Re: **Design Review Application – DSRFY2023-0011**
Alworth St. – Revisions Resubmittal

No Park Units LLC
New Industrial Flex
5260 N. Sawyer/Alworth St. Garden City, ID

Elevations
Renderings

West Elevation

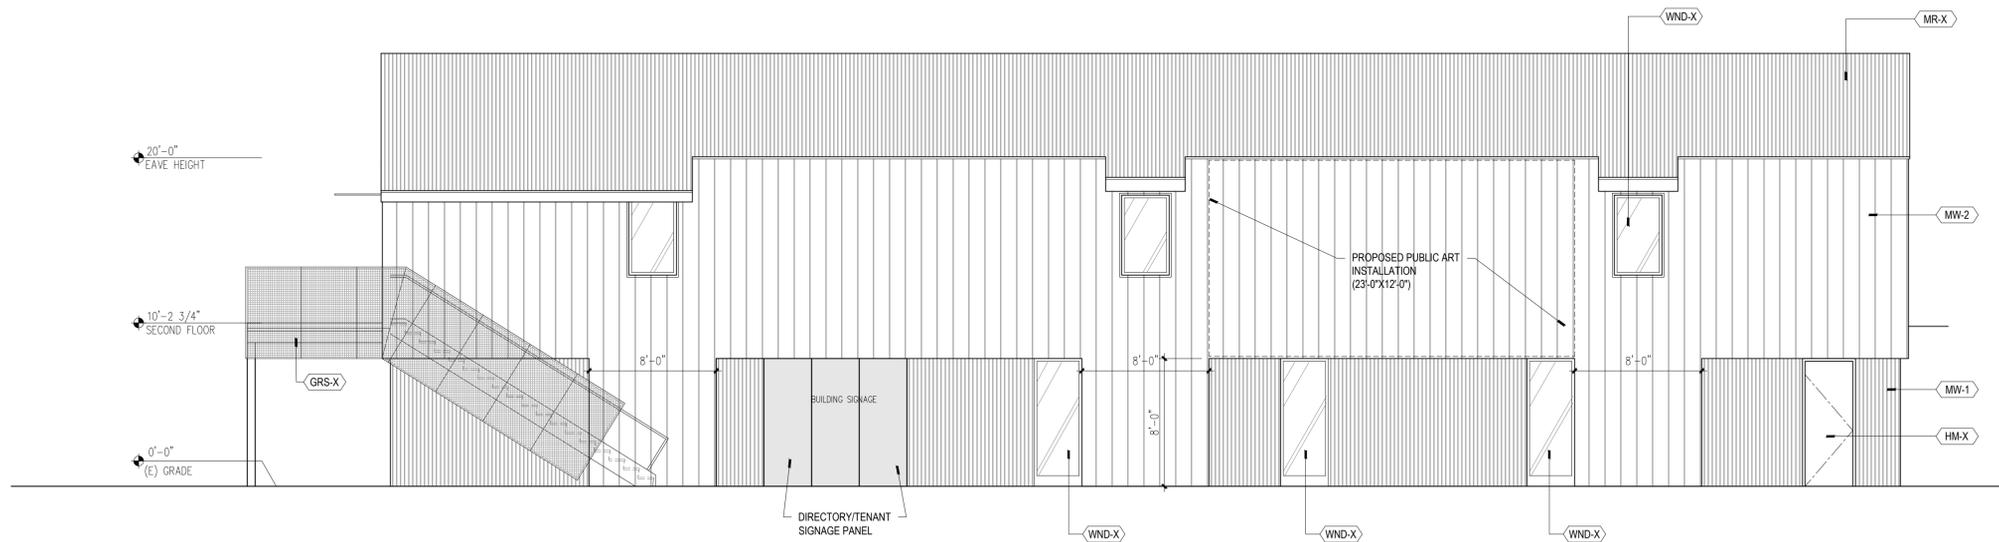
- Three windows (3'x8' each) provided along the East and West facades.
- The upper wall panel extended to the lower level at three locations (8' wide, centered on the upper windows) to break up the façade along this area, provide shadow lines and additional interest.
